MIL-C-172C
AMENDMENT 6
15 February 2001
SUPERSEDING
AMENDMENT 2
20 October 1966

MILITARY SPECIFICATION

CASES; BASES, MOUNTING; AND MOUNTS VIBRATION (FOR
USE WITH ELECTRONIC EQUIPMENT IN AIRCRAFT)

FIGURE 6. Automatic locking device.

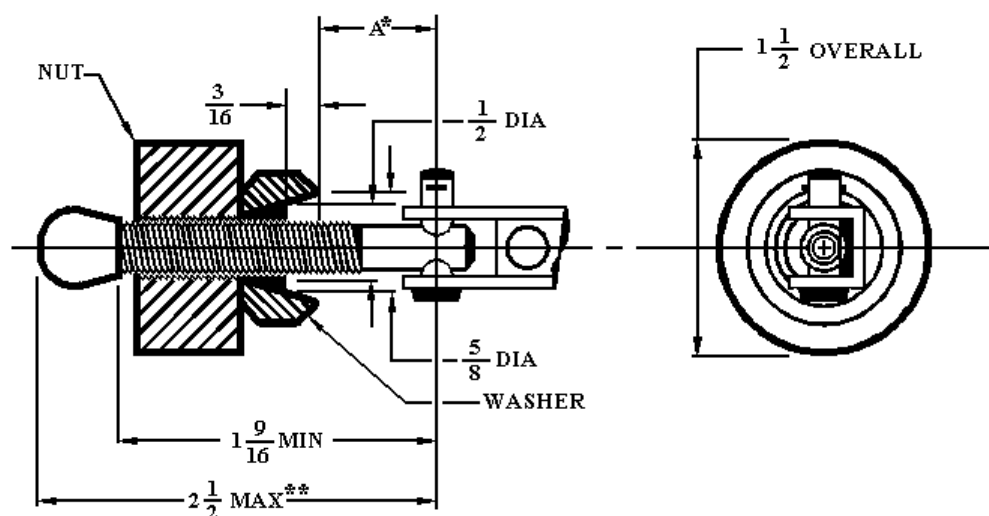
3.5.2.1: Delete and substitute:

“3.5.2.1 Locking devices.

“3.5.2.1.1 Safety wiring. Safety wiring, passing through holes provided for that purpose in the thumb nuts or wing nuts of the fastener assembly and in the mounting base, shall be used to prevent loosening thereof under vibration.

“3.5.2.1.2 Automatic locking devices. For all Air Force procurement only automatic locking devices shall be use in all cases, bases, and mounts to prevent loosening thereof under vibration. Dimensions shall be within the envelope shown in figure 6. For Army and Navy procurement automatic looking may be used provided they are specified by the procuring activity.”

Insert figure 6:

* CLEARANCE ON OPEN OR EXTENDED POSITION 1-3/8 MINIMUM FOR DIMENSION A

** THIS DIMENSION SHALL BE NO GREATER THAN NECESSARY TO MEET THE MINIMUM CLEARANCE OF DIMENSION A

MATERIAL: CORROSION-RESISTANT STEEL
